From: Watkins, Robert
Sent: Wednesday, December 22, 2021 2:07 PM
To: jd@bdarchitects.com
Cc: Werner, Jeffrey B
Subject: December 2021 BAR Decision

BAR 20-11-03

612 West Main Street (also 602-616), Tax Parcel 290003000

Project: Construction of a mixed-use building

**WEST MAIN STREET
ELEVATION**

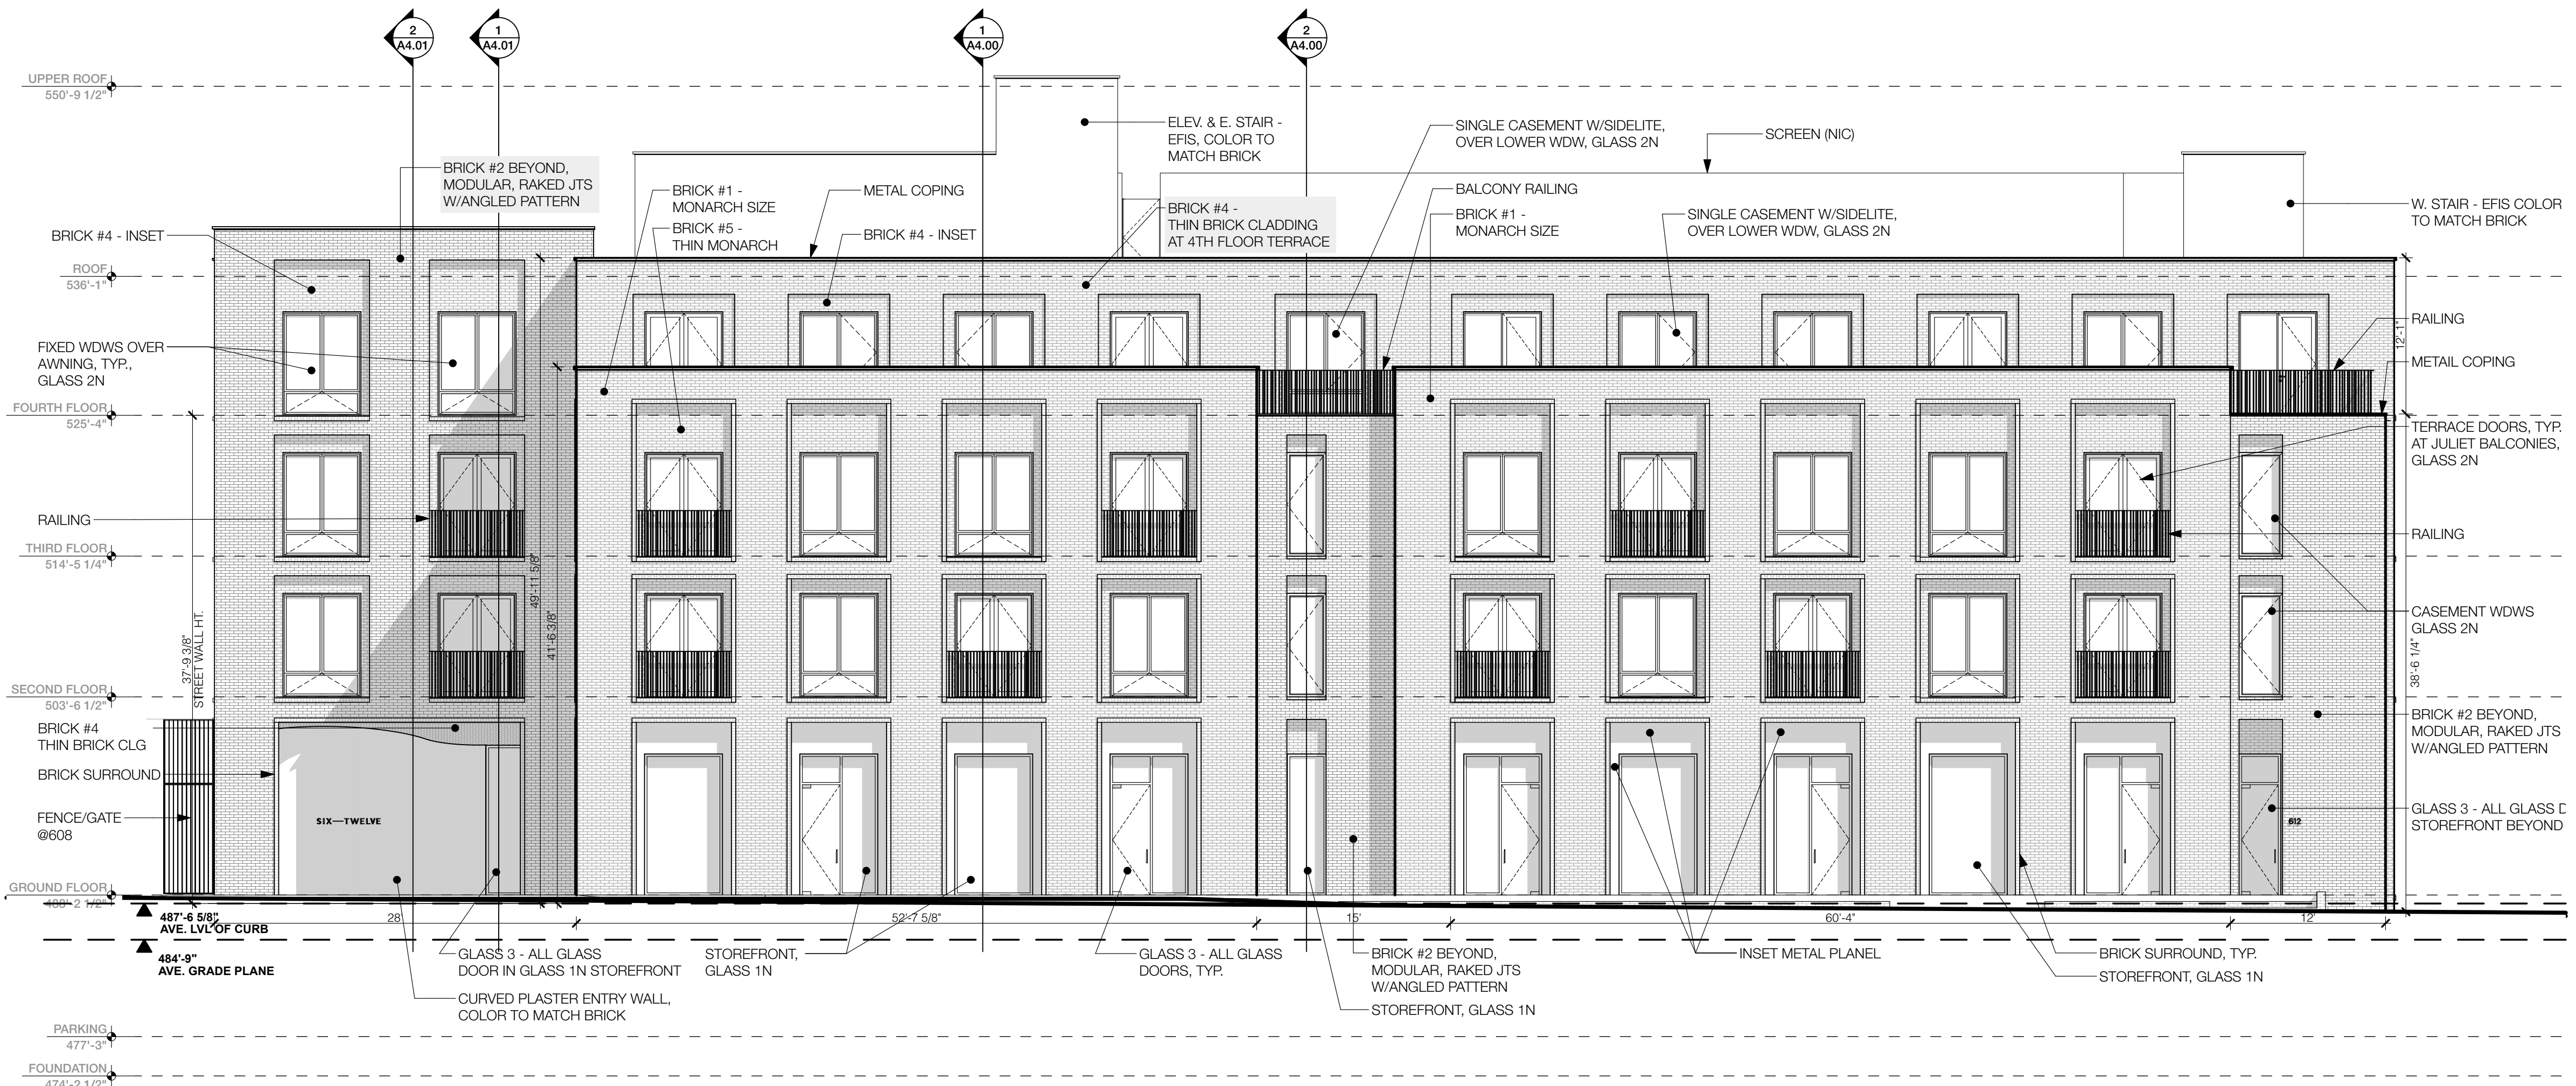
Mr. Gastinger – I feel that the landscape, through the planters, does feel very token at the moment and not really contributing to a sense of scale or to better use by the pedestrian or the public. That's where some context with West Main could be useful. I just want to point out that this rendering is trying to do the best to put the sun in a position where you're getting a little bit of shadow. That must be 7 in the morning on July 21st. Being the north façade, it has to work that much harder to have the kind of push and pull to really feel like there is enough depth within that façade to create that vertical rhythm that we have been talking about. Almost every part of the day, this is not going to have a lot of sun on the façade. Shadow lines are not going to be that pronounced. The use of color with the depth of the window mullions are really critical. Maybe using color more between the pieces might be one way of further modulating the façade.

Mr. Schwarz – On the subject of massing, I am a little torn. I look at your elevations and I find it elegant. I want to think to what we currently have in Charlottesville. If you look at The Flats versus The Standard, the Flats has a very monolithic elevation. For some strange reason, The Standard is infinitely worse. It has a little street module that is a different color, material from the one next to it and the one next to it. There is a lot of depth of the façade. It's terrible. It doesn't work. I want to be a little cautious. If we tell them to just paint modules on it, or change the height of one versus the height of another, we have to be careful.

Ms. Lewis – I feel that the surround has too much detail at this point. I think the massing meets our guidelines. I know that there are constraints under the SUP. I like the programming. I like the fact that it is stepped back from the main mural next door. I feel that I am looking at Neiman Marcus building at Lenox Place in Atlanta or Highland Park in Dallas. It looks like it's a retail building that should have a lot of asphalt around it. Instead, it was plopped down on West Main Street. I am not being disrespectful to the applicant or his representative at all. I actually do like the palate of the building, the direction of a very clean looking palate. I agree that West Main has gotten some color. The color doesn't bother me. I feel like the huge scale of the retail store front windows is really different than much of what we see. It would be the largest building with windows on the ground floor around here. I am looking at our guidelines on construction. There are actually a lot of guidelines for new construction on West Main. One of the guidelines is human scale, which includes balconies, porches, entrances, store fronts, and decorative elements. If the floors above the ground floor are residential, how about some balconies. This is a street. How about some street engagement? I don't feel this building has any street engagement. This is a significant pedestrian corridor for us. It's the most important corridor in this city. It connects the University and the downtown business district. To use some of these elements at the street level to reinforce elements seen elsewhere in the districts, such as cornices, entrances, display windows. Human scale is in two different guidelines that are under height and width. It is specifically applied to new construction. We don't know whether these retail spaces would even have entrances off of West Main. We have been told about the door into the residences. I really don't see any doors on those store fronts. I am assuming each of them would have a separate

Mr. Mohr – It's there because it is a qualitative issue. You have something that addresses the qualitative. I wanted to touch on something that Ms. Lewis was saying. Part of what makes that whole lower story seem a little off putting from a scale standpoint is that the planter solution seems suburban. I think that's part of it. I think the planters do have to go away. The trees are great and an Italian classical sense. I also don't see them as playing well with the street trees. I think that whole sidewalk scene needs to be re-thought.

Mr. Schwarz – I am going to add on the subject of materials that although I would love to see an unpainted light colored brick, painted brick would be far superior to stucco just because of stucco means EIFS. I would want to see something hard and durable on the ground floor. I don't know if there is another masonry products that you could look at.

Ms. Lengel – I would like to talk a little bit about the cornice line. It seems like you might be adding a thin seam to emphasize the cornice line and the verticality of the piers. Is that correct or is that something from the sketch up model that created the rendering?

Ms. Lengel – I guess that I would like to see some more emphasis on that detail.

LANDSCAPE PLAN
612 WEST MAIN STREET

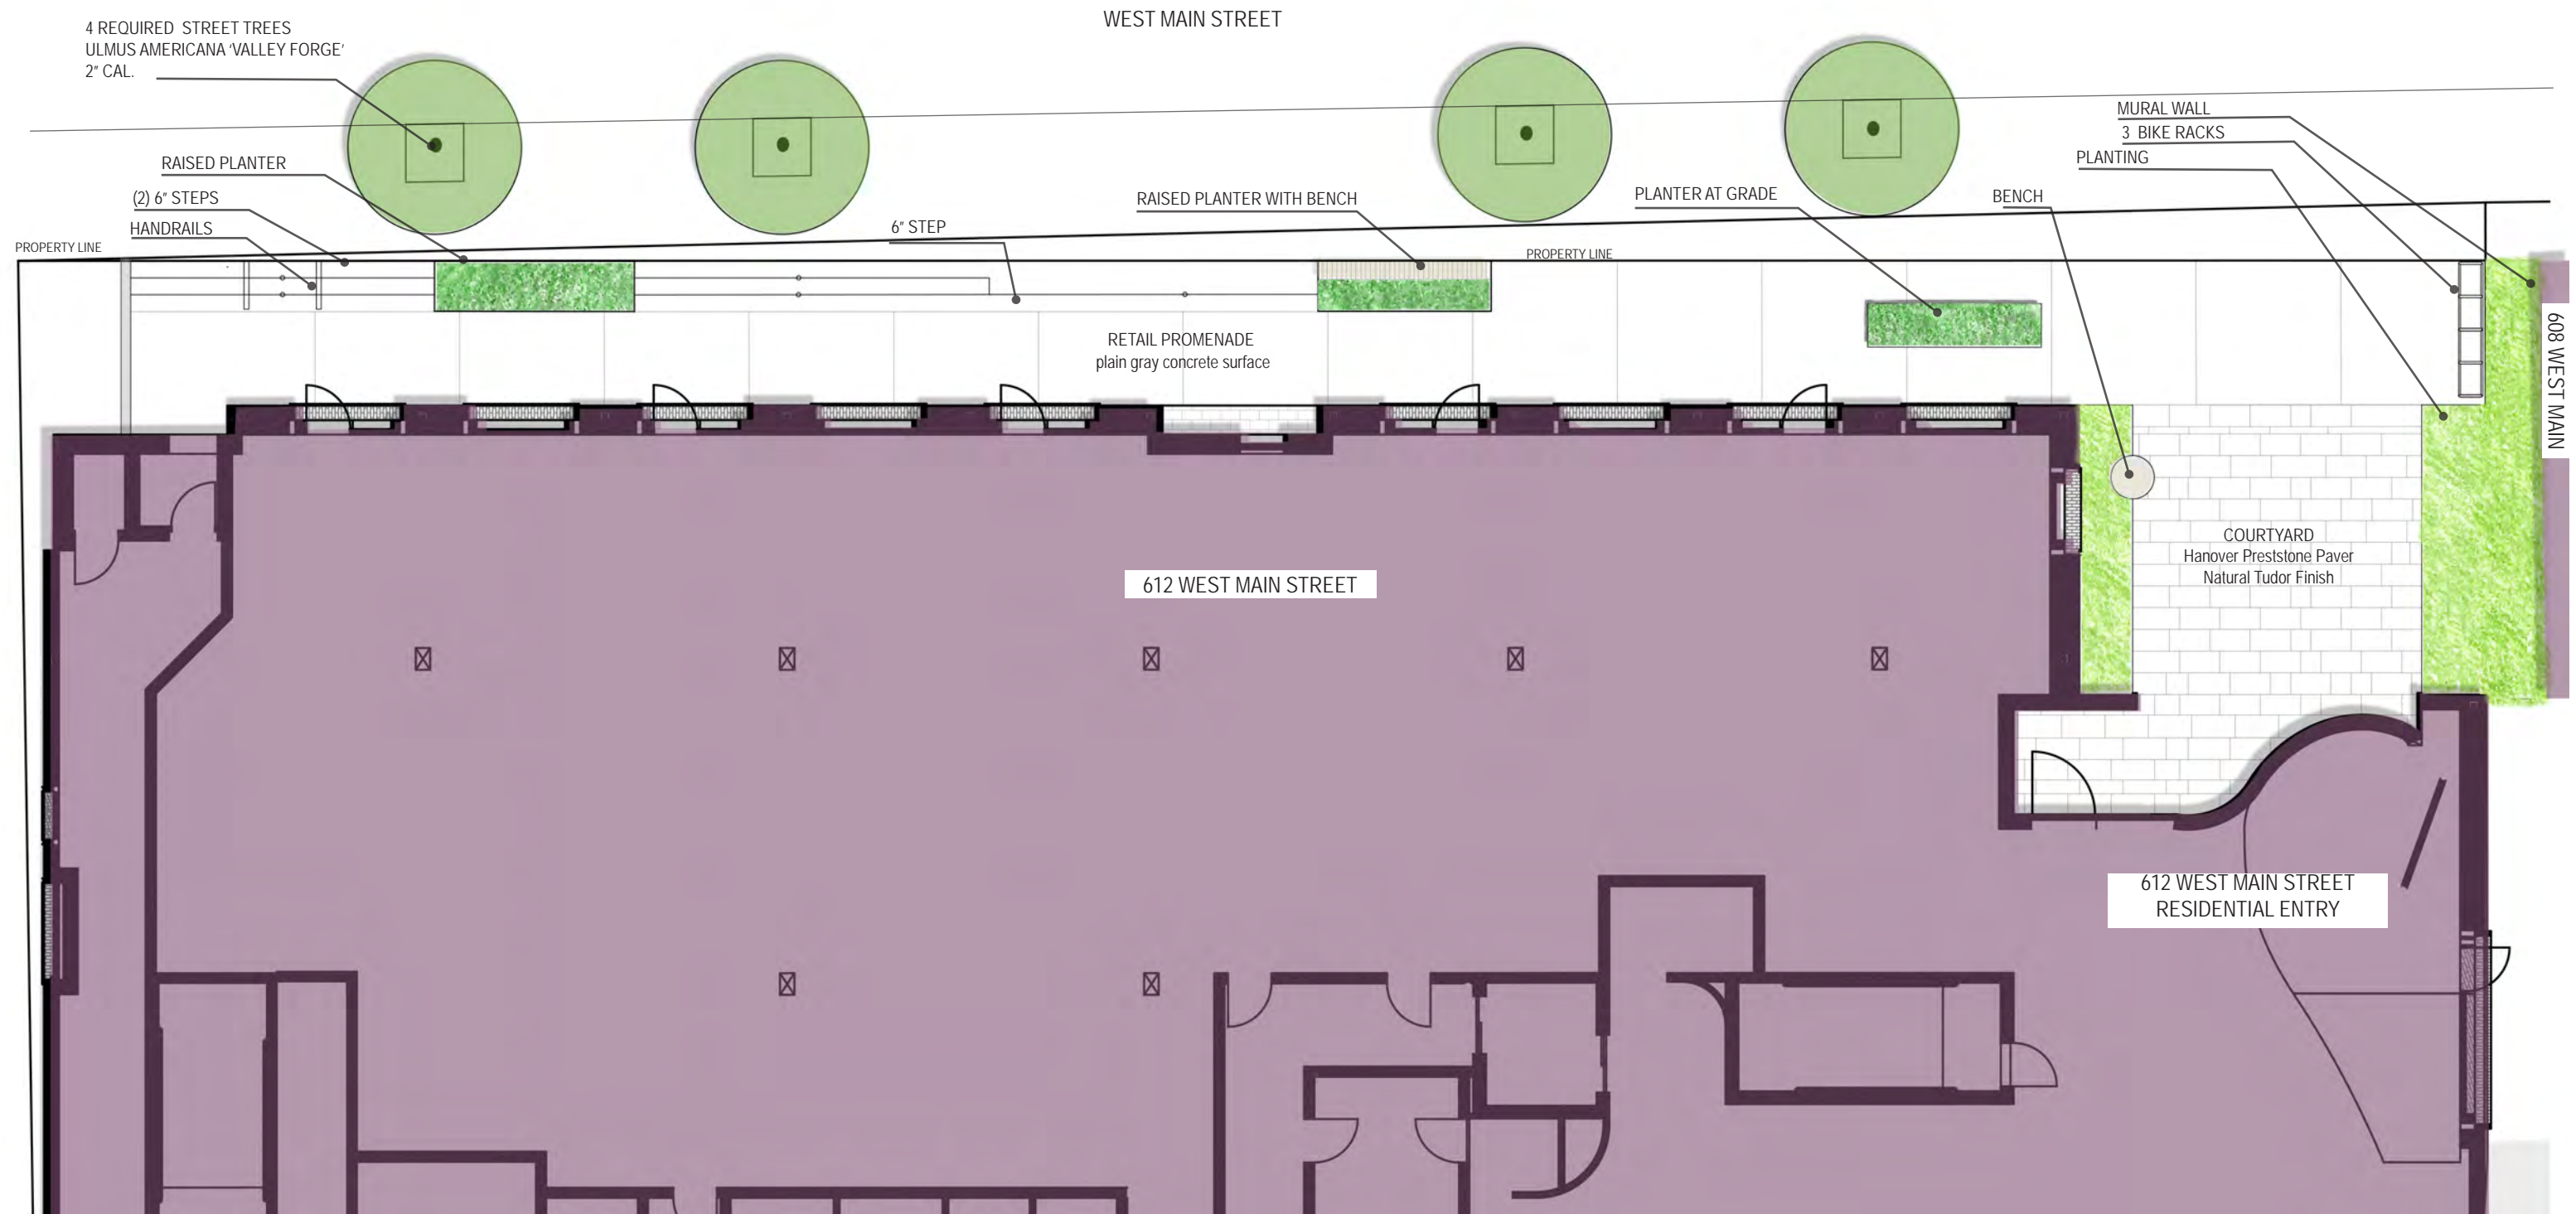
Mr. Lahendro – The planters look like barriers to me between the building and the sidewalk. I worry that the planters have some impact upon the size of the trees being planted. We're replacing some

really lovely large canopy trees in this area. They are being cut up by the utility people with their chainsaws. They are significant trees. I would hope that we will be trying to put back something larger and provide the kind of planting for that.

Mr. Bailey – I would be totally against the planters. I think it needs to be opened entirely and put in canopy trees along the street to make it friendlier.
